Informal document **GRE-92-34**
92nd GRE, 22-25 April 2025)
agenda item 13(a)

Proposal for amendments to GRE-92-12e

Driving task architecture according to R157

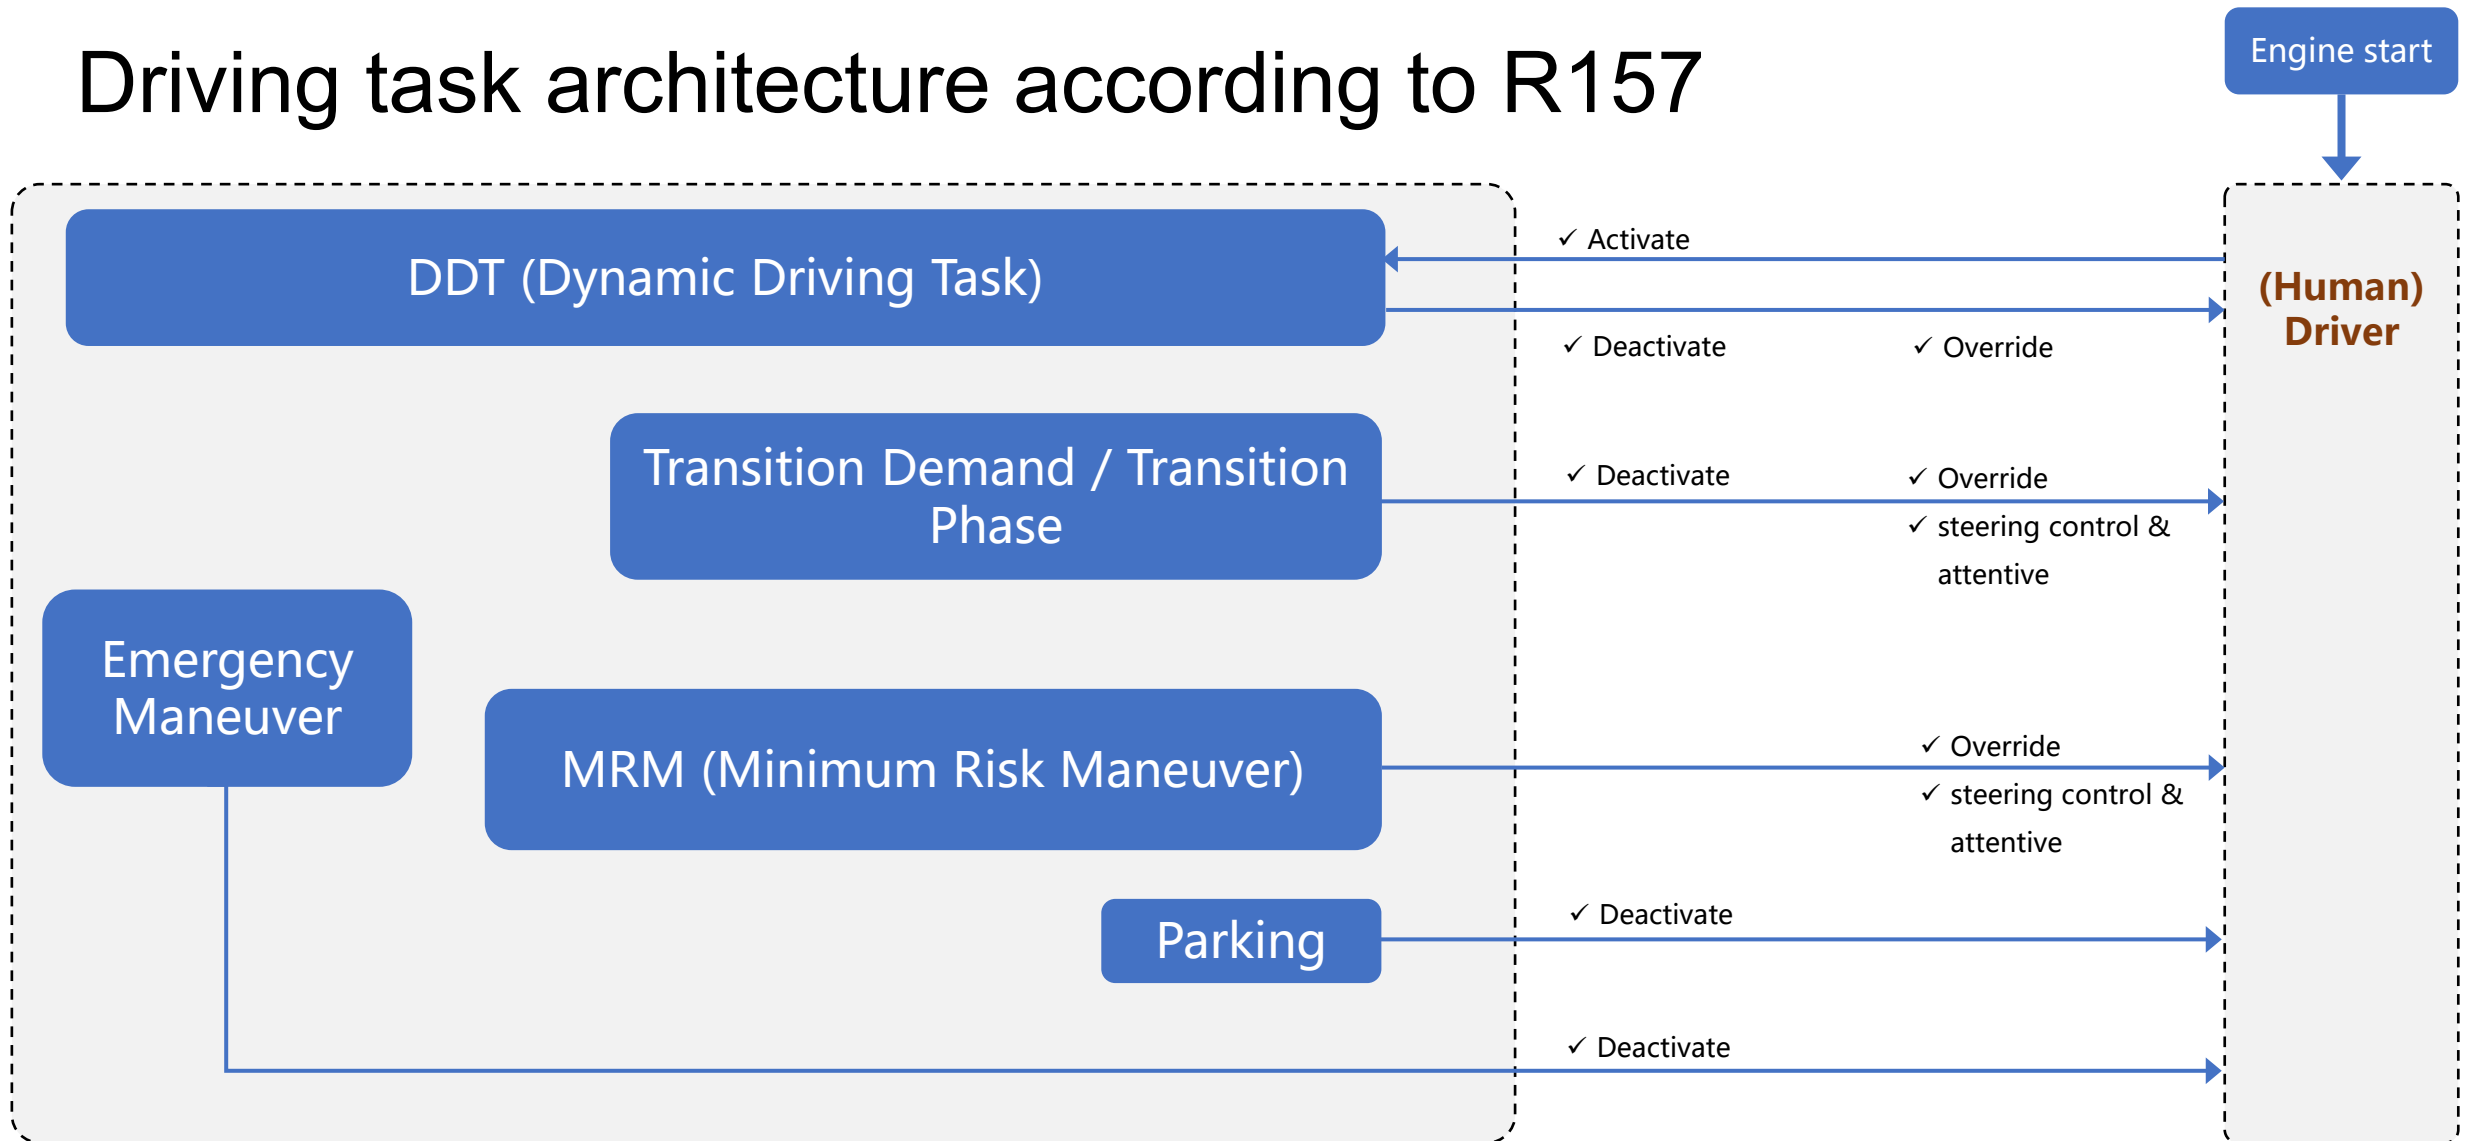
~~"5.35.12. Driver Assistance Projections, which are intended to support the driver only, shall not be activated if the ADS is active."~~

- During DDT phase, surrounding risks should also be earlier indicated to human driver, to help the driver to make correct decisions, and as a positive effect of predicted trajectory light, early identification of risks on driving lane works for both human eyes and camera system. So, **Driver Assistance Projections shall not be deactivated.**
